Lotus Elan M100 Service Bulletins
Series 1 and Series 2 1990 - 1996

SERVICE BULLETIN

Number 1990/11

TITLE: Replacement of headlamp flap 'J' links.

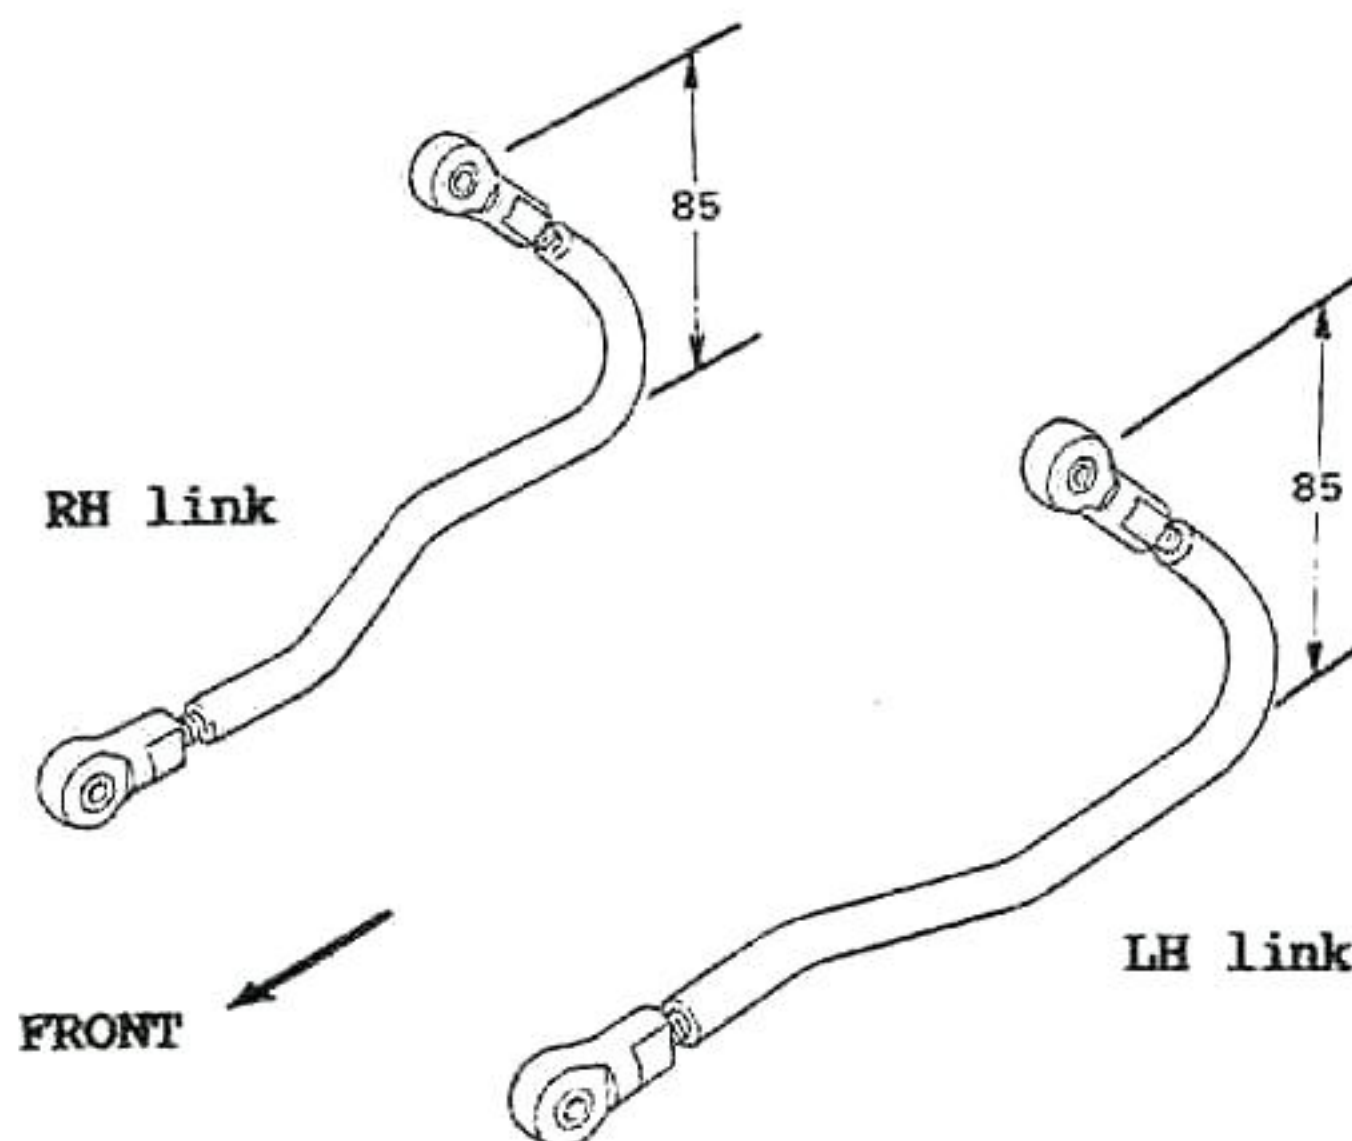
REASON: Incorrect material specification of some links may result in distortion of link and faulty operation of headlamp mechanism.

Part No.	Qty.
'J' Link, RH, headlamp flap operating	D100B0760	1
'J' Link, LH, headlamp flap operating	D100B0761	1
(Note that correct links are identified by a white band)

Before fitting the 'J' links, ensure that each link is correctly identified and adjusted as shown in the diagram.

Description of Single Pivot Headlamp Mechanism

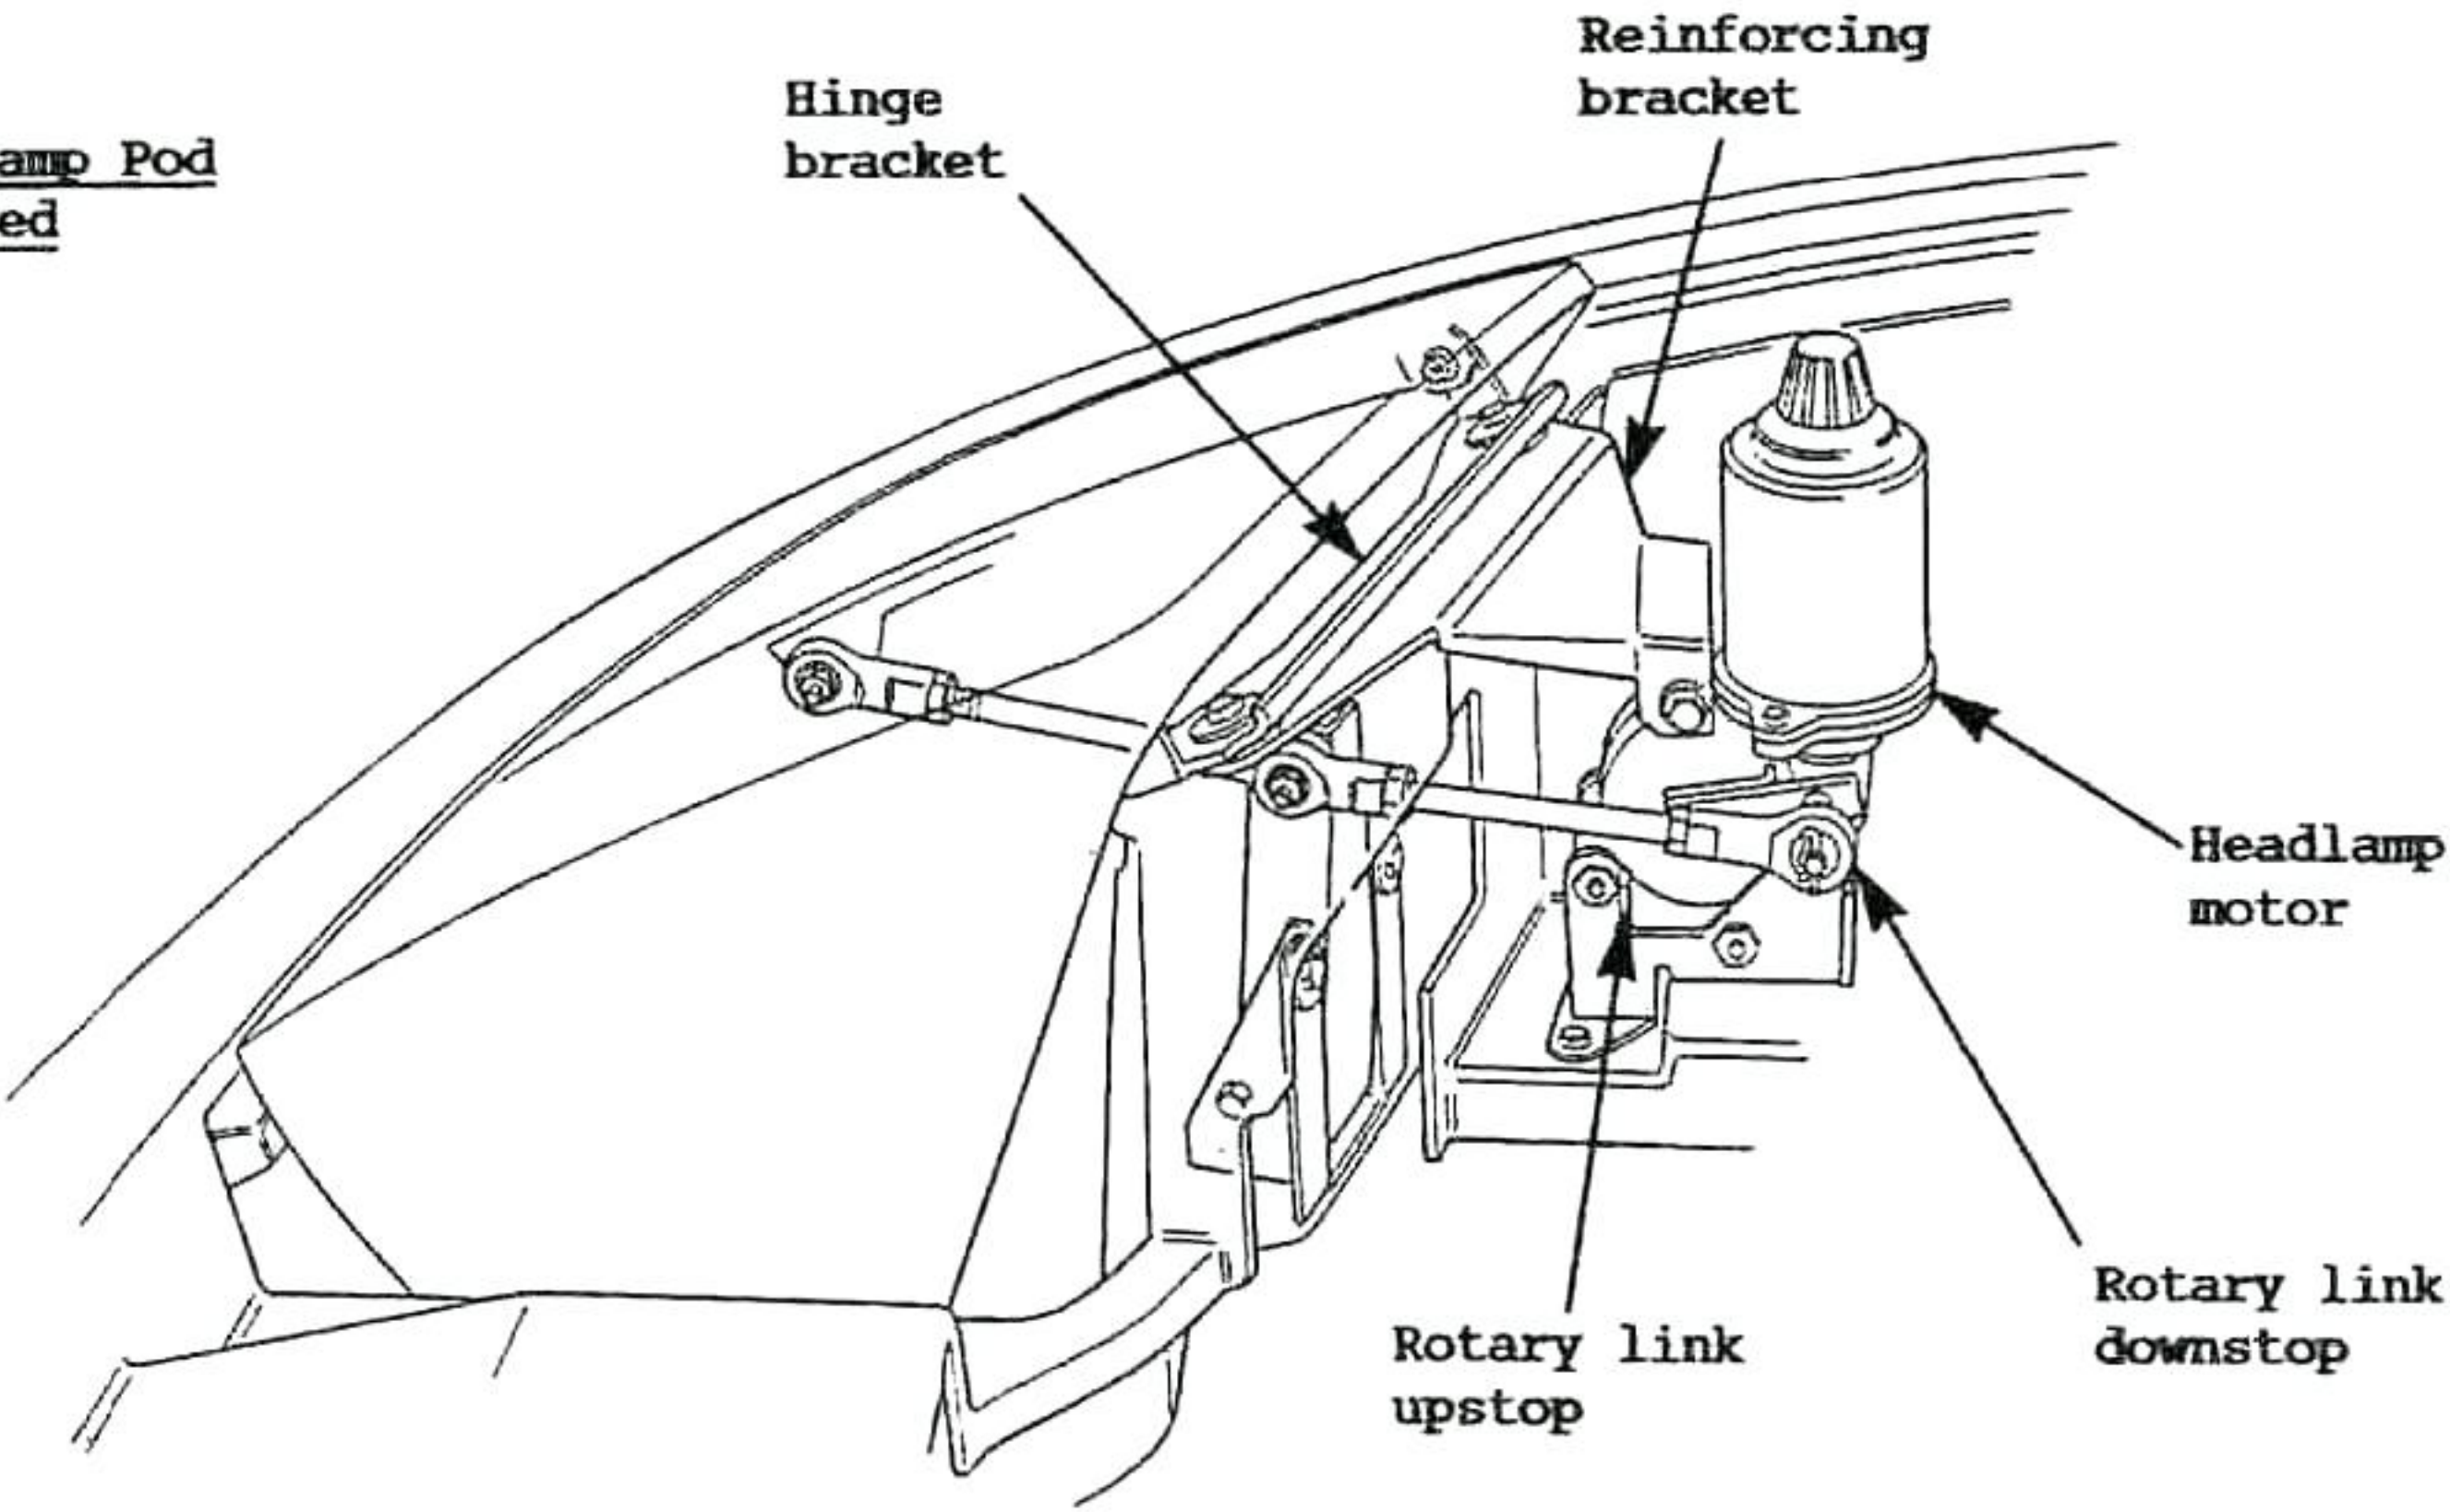
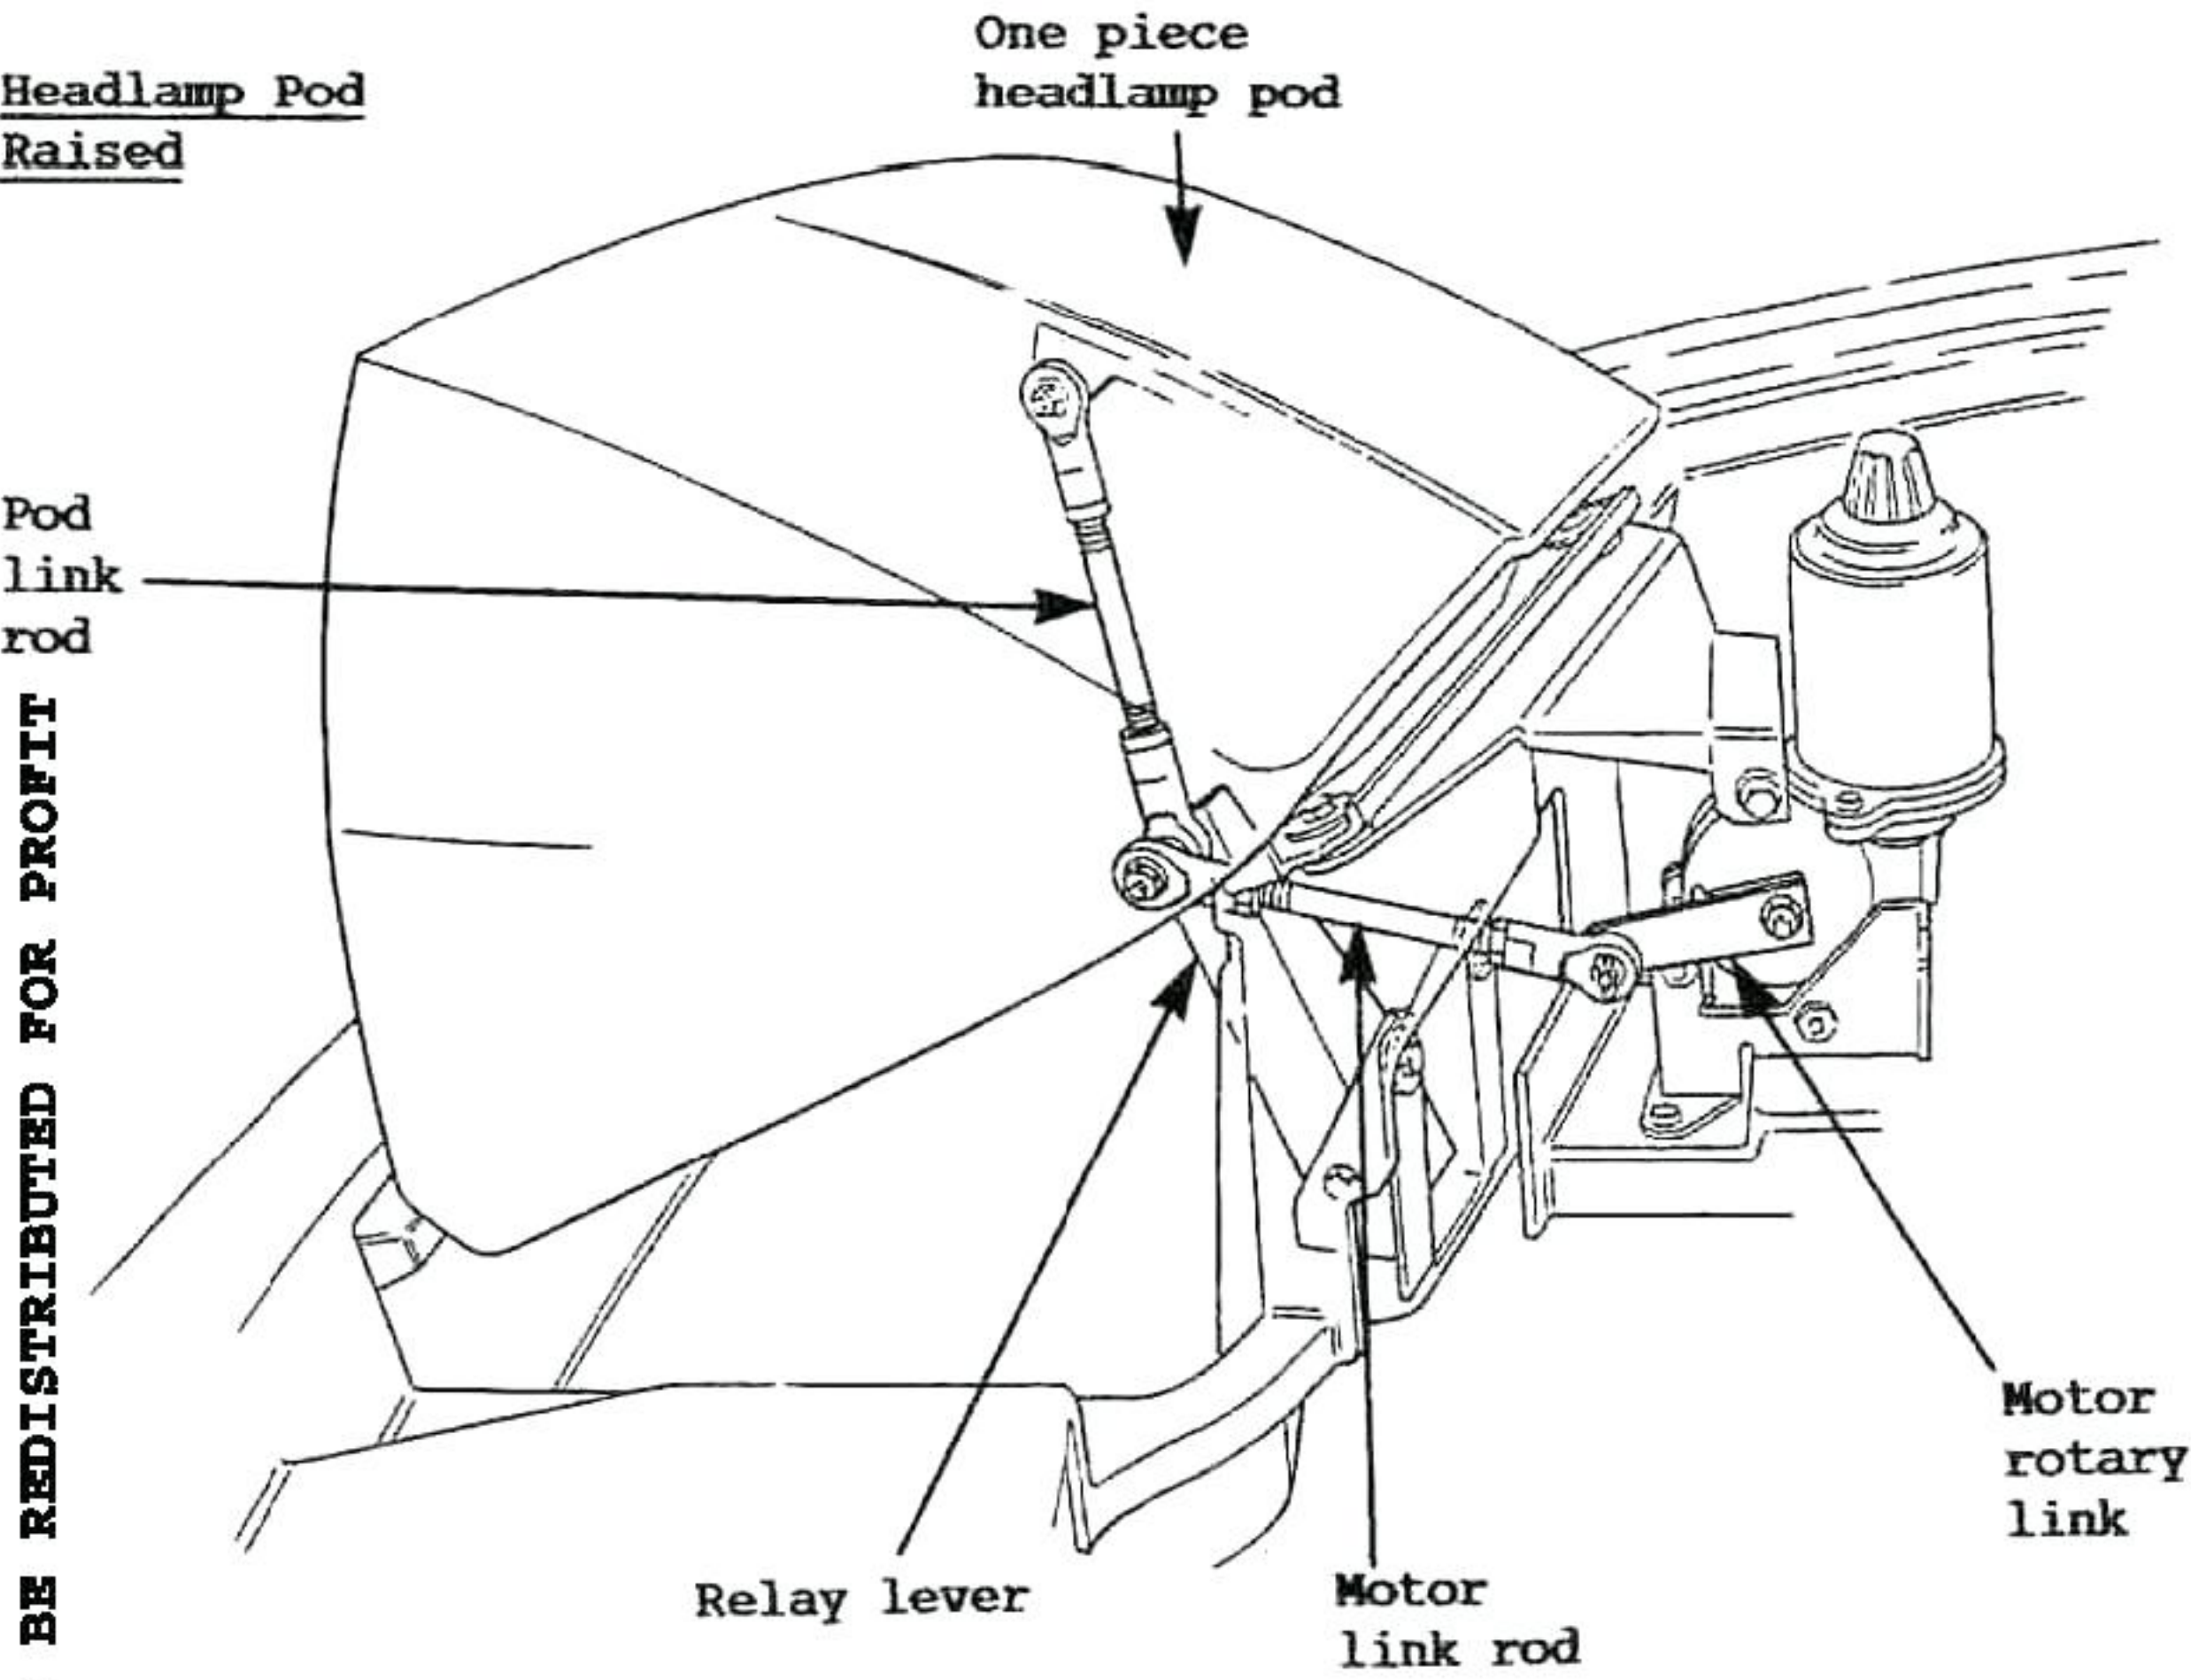
TITLE: Intoduction of 'single pivot' headlamp mechanism. Revised fettling of right hand pod lower edge.

REASON: i) Simplified headlamp mechanism and adjustment procedure.
ii) Revised fettling to provide increased clearance between pod and PAS hose.

1. Pod Shutlines; To adjust the pod shut height and shutlines, slacken the two bolts securing the hinge bracket to the topshell, and add/delete slotted shim washers as necessary to achieve correct pod height and alignment. Position the pod to achieve a 5mm (approx) shut gap between the pod and topshell/bonnet.

2. Motor Link; Adjust the length of the link between motor and relay lever to 140 mm between ball joint centres, with an equal amount of thread showing at each end of the link. Tighten the locknuts, ensuring that the two ball joints are parallel to each other. This dimension will ensure that the linkage goes just over centre with the pod raised, to provide a rigid prop.
